SRS and TDP testing in Clause 95

Adee Ran, Intel

Comment #87 against D2.0

Figure 87-3—Stressed receiver conformance test block diagram

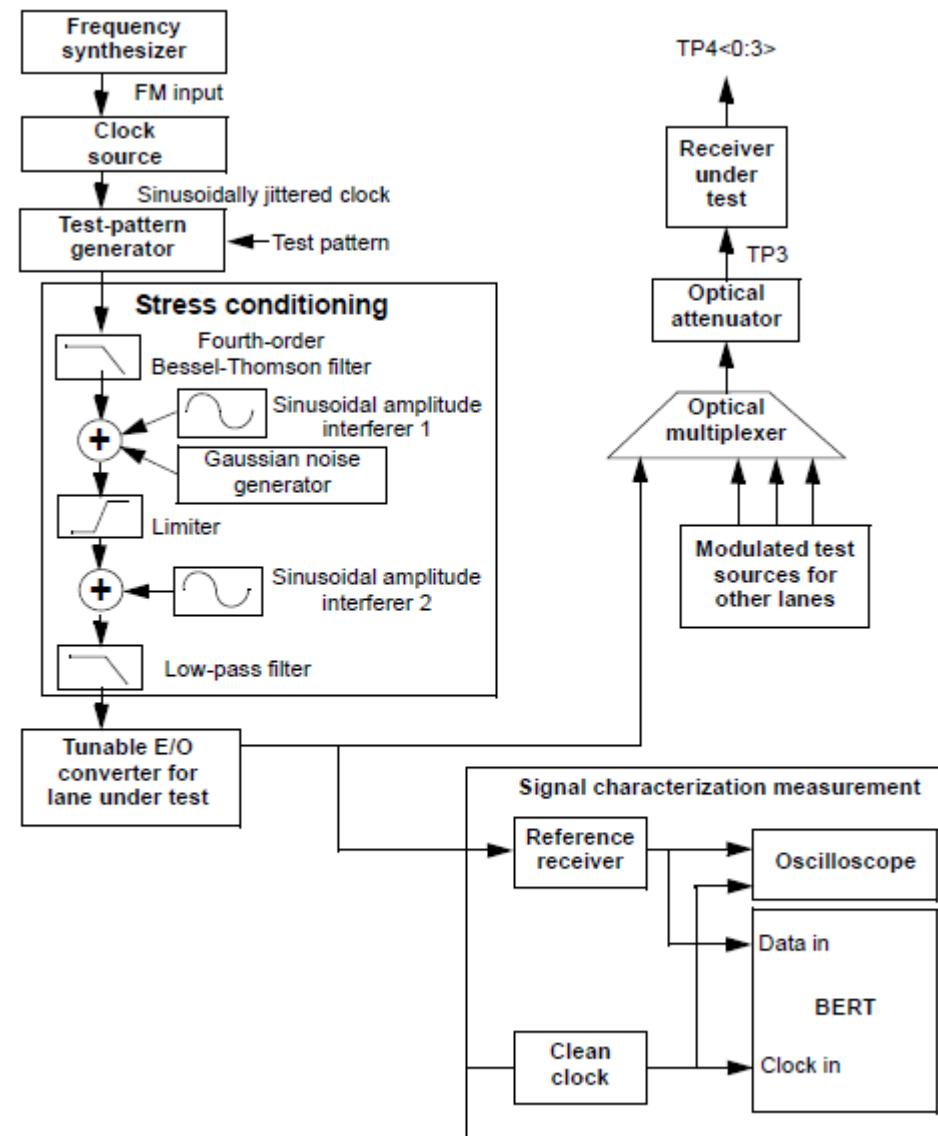
- Draft 2.0 defines SRS quite like 86.8.4.7 (which also refers to 52.9.9) – but for the PHYs defined in clause 86, no error correction is performed; thus, the scrambled idle pattern can be used with the PCS error counters.
 - For clause 86, if Pattern 3 is used, error counting should still be done in the PMA as an additional exception to clause 52, but this is a minor issue.
- In contrast, 87.8.11 does not refer to clause 52 at all, and defines SRS explicitly as a PMD test (at TP4; see figure 87-3). It doesn't specify how errors are counted (thus allowing using either PMA counters or an external device). Clause 88 refers to clause 87 method.
 - For clause 87, if Pattern 5 is used, error counting should be done by the PCS after reconstructing 66-bit blocks across the lanes; this is suitable for an attached PCS, but using an external device is complex and unlikely.

- In Table 95-10, specify using Pattern 3 for SRS and for TDP.
- In 95.8.8, remove the reference to clause 52. Instead, refer to the method defined in 87.8.11 (or its relevant subclauses), with exceptions if necessary.
 - This enables using either PMA or external error counting.
- Delete the beginning of the second paragraph of 95.8.1.1 (Multi-lane testing considerations), as shown in the next slide.
